Bayside Planning Panel

Item No	5.4
Application Type	Development Application
Application Number	DA-2017/142
Lodgement Date	24 October 2016
Property	28A Caledonian Street, Bexley NSW 2207
Owner	Mrs Wafaa Hijazi
Applicant	Space 0.618:1
Proposal	Additions and conversions to approved shed at the rear and convert use to a secondary dwelling
No. of Submissions	One (1) submission objecting to the proposal
Cost of Development	\$80,000.00
Report by	Michael Maloof, Senior Development Assessment Planner

Planning Assessment Report

Application Number:	DA-2017/142
Date of Receipt:	24 October 2016
Property:	28A Caledonian Street, BEXLEY NSW 2207
Owner:	Mrs Wafaa Hijazi
Applicant:	Space 0.618:1
Proposal:	Additions and conversions to approved shed at the rear and convert use to a secondary dwelling.
Recommendation:	Refusal
No. of Submissions:	One (1) submission objecting to the proposal has been received.
Author:	Patrick Waite – Creative Planning Solutions Pty Limited
Date of Report:	16 August 2017

Figure 1 - Proposed/existing rear structure, highlighted in purple, which is the subject of this DA.

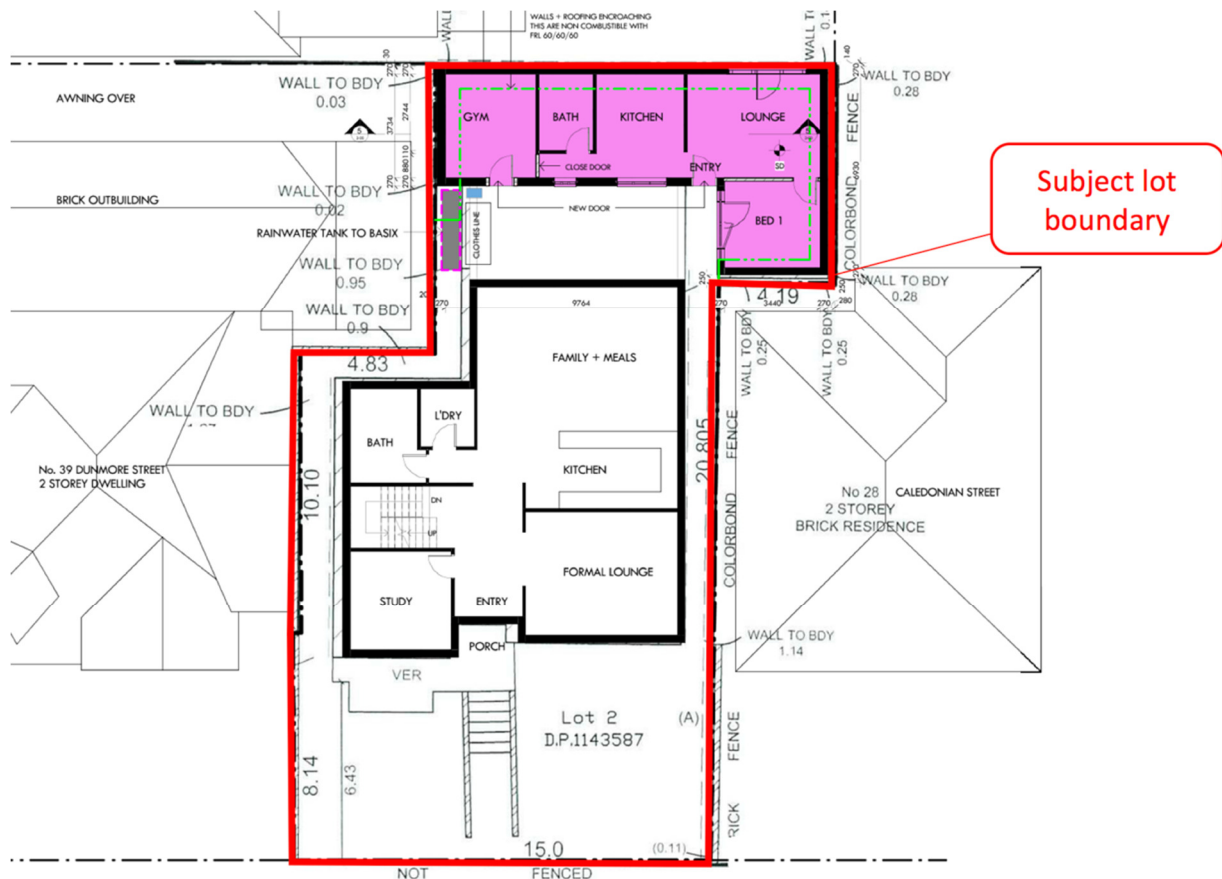
The submitted Ground Floor Plan, prepared by Space 0.681:1, identifies that the structure for which consent is sought is 60.63m² in gross floor area (GFA), and built up to the rear lot boundaries.

The structure contains a bedroom, lounge room, kitchen, bathroom, and a gym. An existing door that provides access to the gym from the remaining rooms within the structure is identified to be 'closed' on the plan. Refer to **Figure 1**.
